Access Compliance Report Public Rights-of-Way (Curb Ramps)

Main Street: ELVIRA_AVE Cross Street: PURDY_ST Location: NW

ADA ID: RPRK211005135436 Ramp Type: Type 1 - Perpendicular Diagonal Initial Pass/Fail: Fail Overall Compliance: No Severity Score: 16

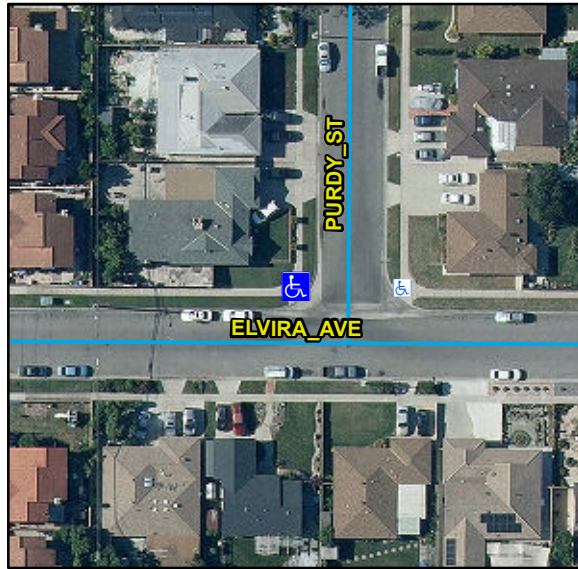
Compliance	Description	Data	Compliance	Description	Data
N/A	Ramp Length (in)	103	N/A	Flare Type LT	
Yes	Ramp Width (in)	48			N/A
No	Ramp Run Slope (%)	11	N/A	Flare Slope LT (%)	N/A
No	Ramp Cross Slope (%)	2.8	N/A	Flare Traversable LT	N/A
N/A	Landing Present	N/A	N/A	Flare Type RT	
N/A	Landing Length (in)	N/A			N/A
N/A	Landing Width (in)	N/A	N/A	Flare Slope RT (%)	N/A
N/A	Landing Run Slope (%)	N/A	N/A	Flare Traversable RT	N/A
N/A	Landing Cross Slope (%)	N/A	N/A	DWS Provided	N/A
N/A	Landing Movement Obstructed?	N/A	N/A	DWS Contrast	N/A
	Landing Movement Type	N/A	N/A	DWS Length (in)	N/A
N/A	Landing Shared	N/A	N/A	DWS Full Width	N/A
N/A	Clear Space	Yes	N/A	DWS Offset Left (in)	N/A
N/A	Clear Space To Crosswalk (in)	N/A	N/A	DWS Offset Right (in)	N/A
N/A	Marked Crosswalk 1	No	N/A	Marked Crosswalk 2	No
	Crossing 1 Direction	S		Crossing 2 Direction	E
	Marked Crosswalk 1 Width (in)	N/A		Marked Crosswalk 2 Width (in)	N/A

N/A	Ramp Inside Crosswalk 1	N/A	Yes	Ramp Inside Crosswalk 2	N/A
	Crossing 1 Slope (%)	7.5		Crossing 2 Slope (%)	0.3
	Crossing 1 Cross Slope (%)	1.2		Crossing 2 Cross Slope (%)	1.3
N/A	Gutter Ponding	N/A	No	Curb Slope	7.1
Yes	Gutter Lip Height (in)	0		Road Run Slope (%)	0.6
N/A	Gutter Run Slope (%)	N/A		Road Cross Slope (%)	5.2
N/A	Gutter Cross Slope (%)	N/A			
Yes	Overall Surface Condition: Acceptable		Yes	Perp Joint Present	Yes
	Cross Gutter Present?	Yes		Spandrel Present?	Yes
	Replace Cross Gutter?	No		Replace Spandrel?	No

Remove & Replace Curb Ramp With Two New Directional Ramps or Equivalent.
